<b>Title - Sujet</b> Truck Scale-CFB Halifax Truck Scale-CFB Halifax	
<b>Solicitation No. - N° de l'invitation</b> W0100-222377/B	<b>Amendment No. - N° modif.</b> 001
<b>Client Reference No. - N° de référence du client</b> W0100-22-2377	<b>Date</b> 2022-08-25
<b>GETS Reference No. - N° de référence de SEAG</b> PW-SHAL-418-11560	
<b>File No. - N° de dossier</b> HAL-1-87123 (418)	<b>CCC No./N° CCC - FMS No./N° VME</b>
<b>Solicitation Closes - L'invitation prend fin</b> <b>at - à 02:00 PM</b> Atlantic Daylight Saving Time ADT <b>on - le 2022-09-06</b> Heure Avancée de l'Atlantique HAA	
<b>F.O.B. - F.A.B.</b> <b>Plant-Usine:</b> <input type="checkbox"/> <b>Destination:</b> <input checked="" type="checkbox"/> <b>Other-Autre:</b> <input type="checkbox"/>	
<b>Address Enquiries to: - Adresser toutes questions à:</b> Johnson, Alexis	<b>Buyer Id - Id de l'acheteur</b> hal418
<b>Telephone No. - N° de téléphone</b> (873) 354-9858 ( )	<b>FAX No. - N° de FAX</b> (902) 496-5016

Amendment 001 is raised to:

1. Answer bidder questions;
2. Correct an error in 1.1 Reissue of Bid Solicitation;
3. Amend 1.2 Security Requirements;
4. Amend Annex A Statement of Requirement;
5. Amend Attachment 1 to Anne

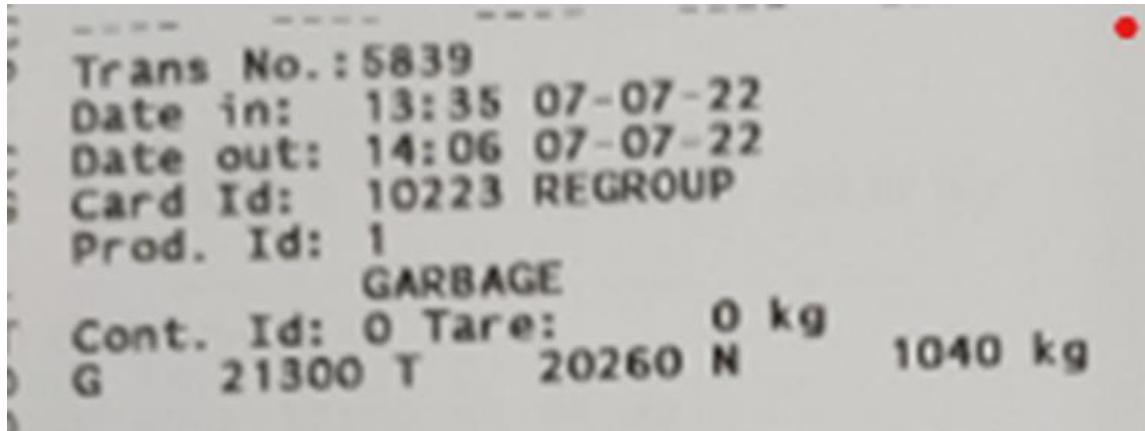
Q5. Kiosk – What do you want on the ticket IE Truck ID , Product, can you show a sample of what your ticket looks like when truck is heading out?

A5. This is what the scale ticket should look like:
